ADDENDUM NO. 3

Reference: North and South Tenant Improvements
Department of Environmental Quality – Salt Lake City, Utah
DFCM Project No. 09254310

Addendum No. A01

Department of Environmental Quality - North and South Tenant Improvements
Building Remodel and Tenant Finish (2 Buildings)
150 North 1950 West and 168 North 1950 West
Salt Lake City, Utah
DFCM Project No. 09254310

**PD
 101**

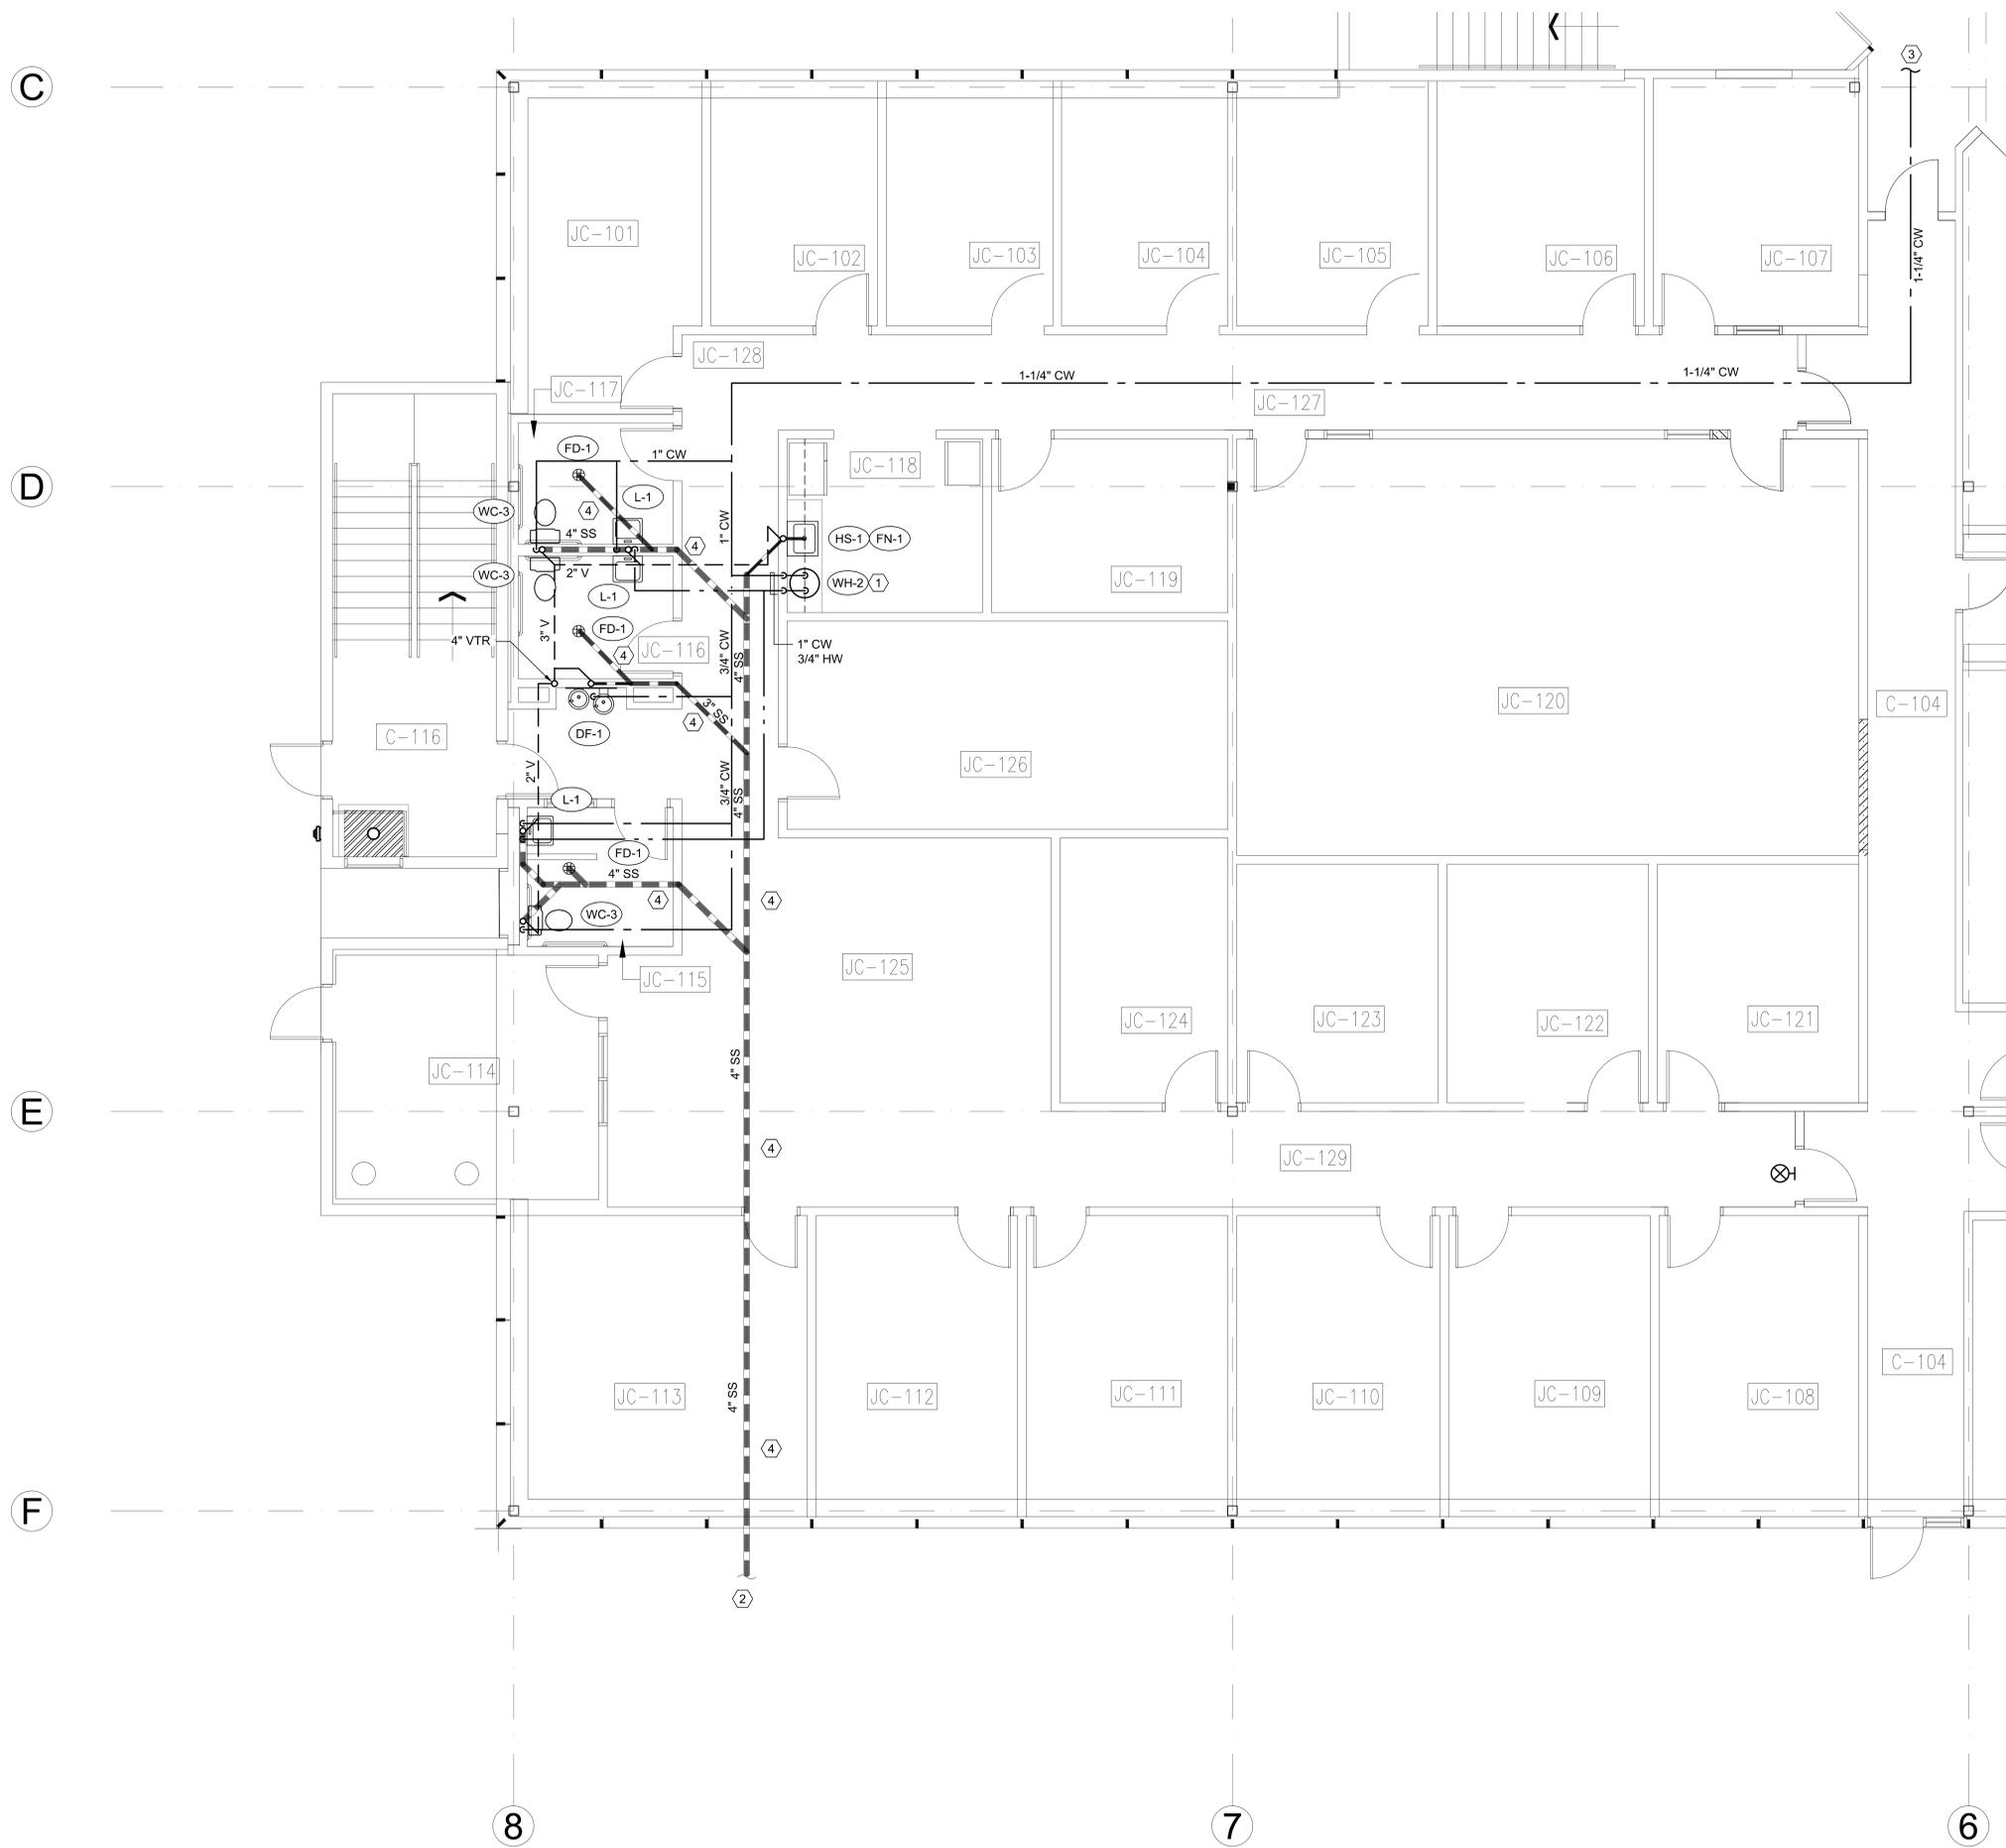
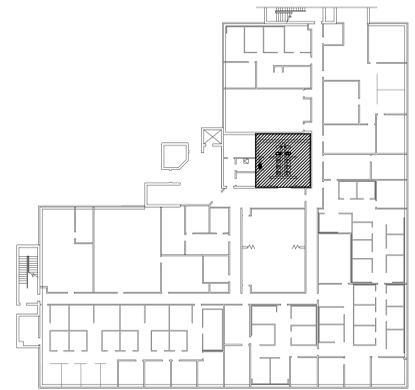
3. **PLUMBING SHEETS:**
QUESTION: 1) In both sets of plans the plumbing drawings are the same, therefore missing plumbing drawings for South Building. Please Clarify?
RESPONSE: The Plumbing sheets were mixed between the two buildings. The Plumbing Sheets have been revised and reissued. See Attached Drawings.

Item I-1. – Please replace the bid set plumbing sheets with the attached.
